STAFF RECOMMENDATION

2534 Ashwood Avenue

February 18, 2015

Application: New construction-addition

1 Site Plan
 Scale: 1" = 20'-0"

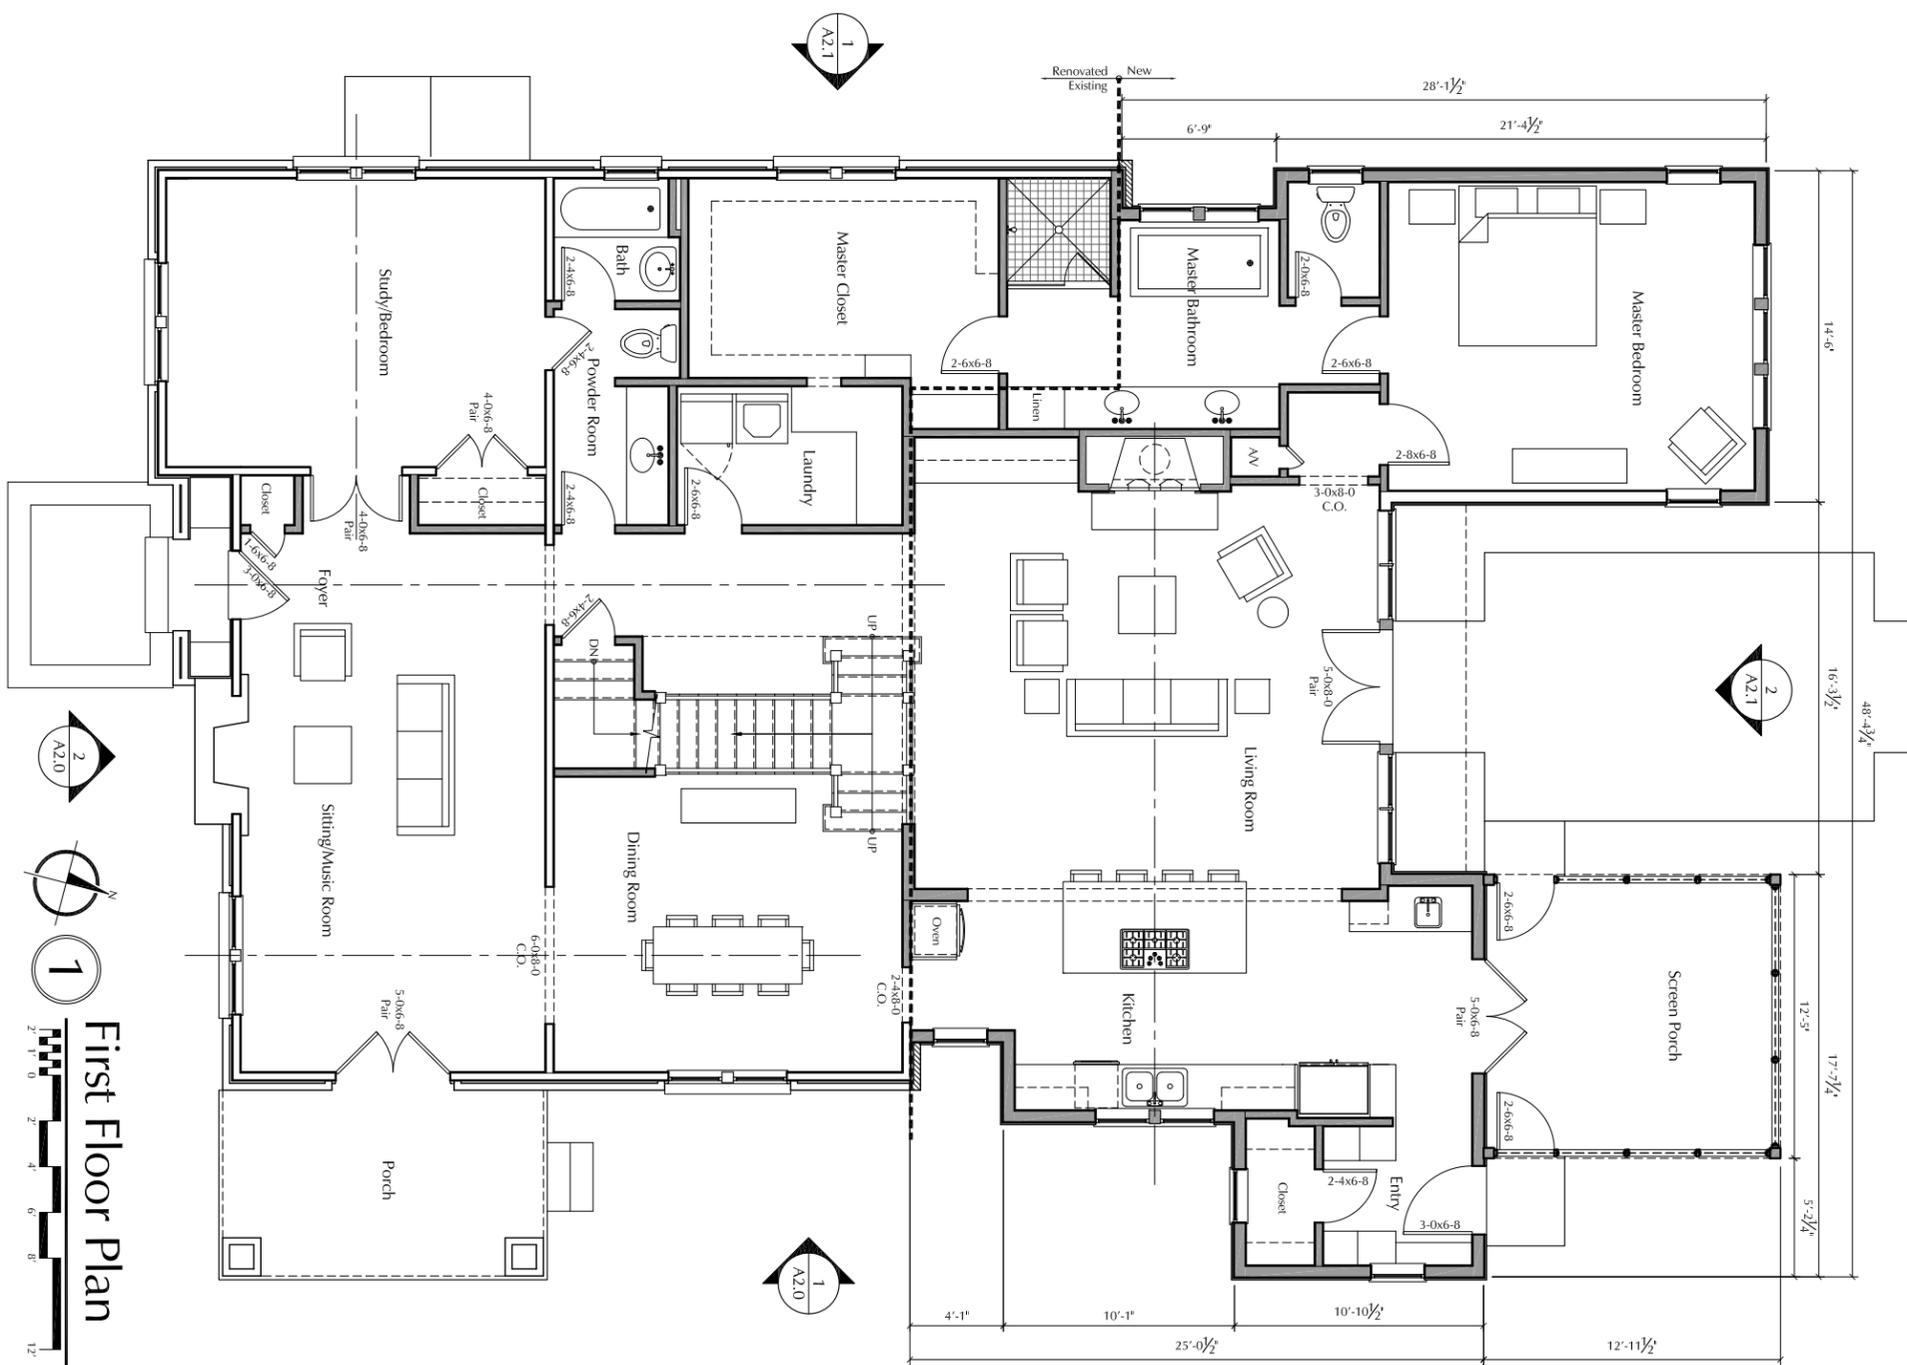
Setback & Rhythm of Spacing: The side setbacks of the addition will be six feet, nine inches (6'9") on the right, and twenty feet (20') on the left. The rear setback will be forty-eight feet (48'). These dimensions meet the base setback requirements of five feet (5') on the sides and twenty feet (20') at the rear. The project meets section II.B.1.c for setbacks.

Drawings:
Elevations
Date:
02.02.15

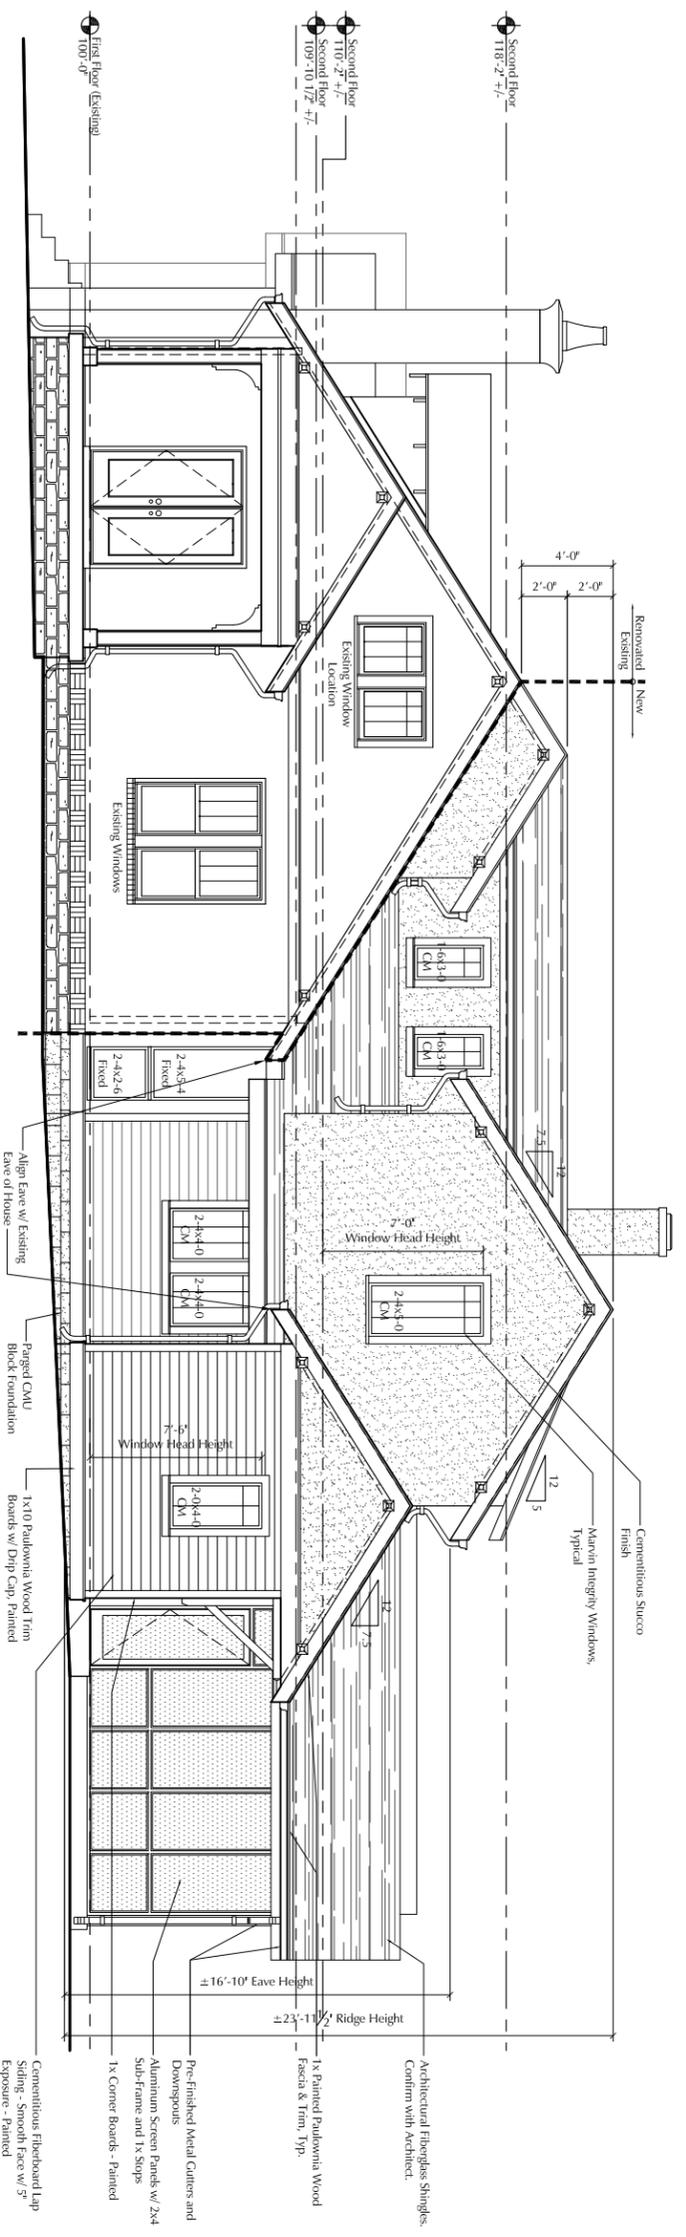
Height & Scale: The project includes a ridge raise, adding two feet (2') to the height of the house. The addition will be another two feet (2') taller, for a total height of approximately twenty-four feet (24'). The tallest portion of the addition will be at a distance of forty-six feet (46') from the front wall of the house. The design guidelines state that an addition may be up to four feet (4') taller than the house, provided that it is at a distance of at least forty feet (40') from the front edge of the existing building. The foundation height will match the existing. Staff finds the project meets section II.B.1.a and b.

Roof form: The addition will have a side gable with 5/12 pitch. The rear first-floor sections are gabled to the rear with 7.5/12 pitch. The existing ridge of the house will be raised in conjunction with the addition. The addition includes an interior chimney. The Commission has not normally approved wall dormers, but in the location submitted, at the rear of the addition, the visibility will be minimal. Staff finds the project meets section II.B.1.e.

Proportion and Rhythm of Openings: No changes to the window and door openings on the existing house were indicated on the plans. The windows on the proposed addition are generally twice as tall as they are wide, and meet the historic proportion of openings. The largest expanse of wall space without a window or door opening is thirteen feet (13') at the rear of the west elevation. Staff finds the project's proportion and rhythm of openings to meet Section II.B.1.g.

1. Staff approve the roofing color, windows and doors prior to purchase and installation.
